Planning Report

The Overlook

Case Summary

Agenda Item	1
Case Number	16-062INF
Proposal	A 3.8-acres subdivision with 15 single family lots and a proposed density of 3.9 units/acre on a site located in Washington Township.
Request	Review and informal feedback regarding an increase in density for this use prior to pursuing formal Annexation into the City.
Site Location	6004-6076 Dublin Road Located on the east side of Dublin Road, south of Marion Street and north of Longview Drive.
Owner/Applicant	Bethel Development Inc., represented by Roger Simmons
Case Manager	Nichole Martin, Planner I (614) 410-4635 nmartin@dublin.oh.us
Planning Recommendation	Discussion and Feedback

Layout

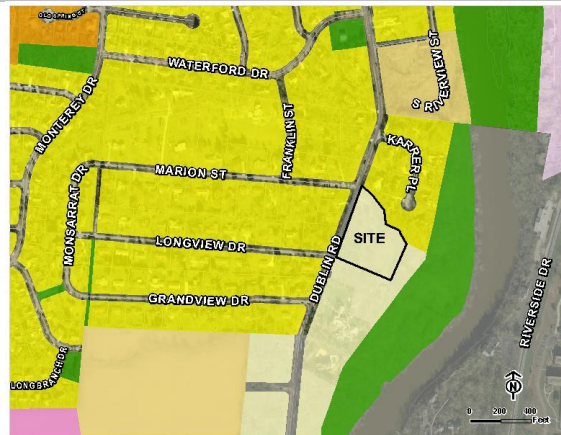
The conceptual site plan depicts 15 single-family lots located on individual lots accessed off Dublin Road by a circular drive. The proposed lots vary in size, but are generally 50' wide and 110' deep. A common open space with associated landscaping and paths is shown located within the center of the circular drive. The applicant has indicated it will likely be passive space, but provide an amenity for the residents. Additionally, the plan shows a landscape buffer and stone wall along the length of the Dublin Road frontage. At this informal stage, the plan shows no accommodations for stormwater management or sidewalks.

Traffic & Access and Stormwater Management	<p>The proposal will require rezoning of the property to accommodate the proposed development. At that time, a full traffic study and stormwater report are required to be submitted to the City for review. At this stage, the plans do not include stormwater management facilities or sidewalks.</p>

<p>3. Does the proposed site layout provide adequate pedestrian connections and open space?</p>	<p>The applicant has indicated the proximity to Historic Dublin as primary driver and inspiration for the proposed development. The site layout depicts a neighborhood scale open space with internal walking paths. Staff has requested further consideration be given to providing traditional sidewalks within the development.</p>
